Architectural Review Board Staff Report

Project Type: Amended Site Development Section Plan

Description: Larry Enterprises – Lynch Hummer, Lot B (Scott Properties): An Amended

Figure 2: 7th Amended Site Development Section Plan

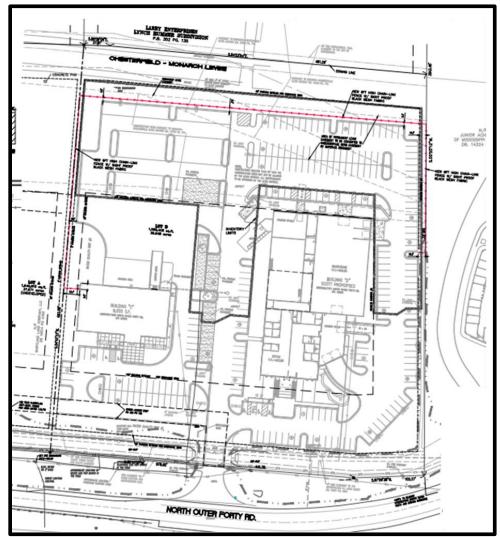
The subject site is served from a single access drive along North Outer 40 Road, and a cross-access easement provides access between the abutting property to the west (McBride Design Center). Parking spaces and drive aisle locations are to remain in their existing condition. Circulation on the site will not be impacted as the proposed screening does not interfere with the parking area or restrict access once on the site. Open access is proposed for the screened area as there will be no gates enclosing the limits of the fence between the two buildings or along the parking area along the east side of the property.
